## Addendum to Staff Report

Community Planning and Preservation Commission  
Certificate of Appropriateness Request

Case No.:	21-90200096
Address:	3040 8 <sup>th</sup> Ave. N.
Legal Description:	KENWOOD SUB BLK 4, LOT 5 LESS E 25FT & ALL OF LOT 6
Parcel ID No.:	14-31-16-46332-004-0050
Date of Construction:	1941
Local Landmark:	Kenwood Section – Northwest Kenwood Local Historic District (18-90300008)
Owners:	Salvatore R. Merola, Jr. and Melissa A. Wine
Request:	Review of an after-the-fact Certificate of Appropriateness request for a front yard fence

**To:** Building Department  
**From:** Luis Huertas, P.E., Professional Engineer  
**Subject:** Revision per City Comments  
**Date:** July 27, 2021

**Figure 1: Low point of scallop**

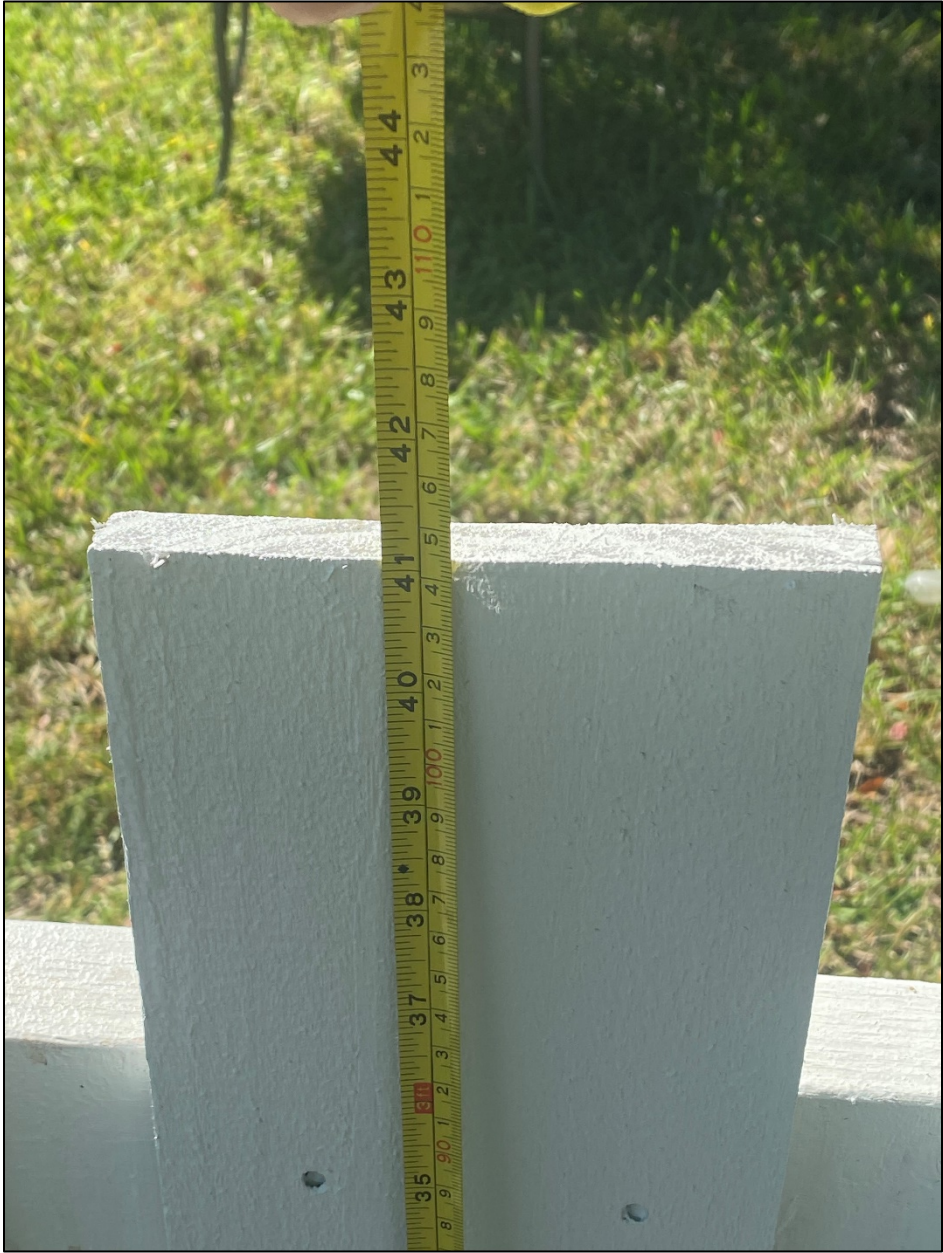
During the Public Hearing, a third party stated that the front fence measured 48 inches in height instead of the 36 inches represented by the application. The Commission deferred consideration of the request to approve the front fence to allow Staff to confirm the fence's height.

All measurements were taken from grade by staff on October 21, 2021.

Per St. Petersburg City Code Section 16.40.040.3.B.6, "Maximum height may vary by up to six (6) inches to allow for grade changes, clearance under fences for maintenance, footers, other obstacles customary to the use intended to be fenced, and reasonable human error."

Staff finds that the front fence at 3049 8<sup>th</sup> Ave. N. generally satisfies St. Petersburg's Design Guidelines for Historic Properties because of its wood material, degree of transparency, traditional but straightforward style which is appropriate to the Minimal Traditional style of the house, and height which features reasonable variation from the 36" height commonly recommended for front fences in historic districts.
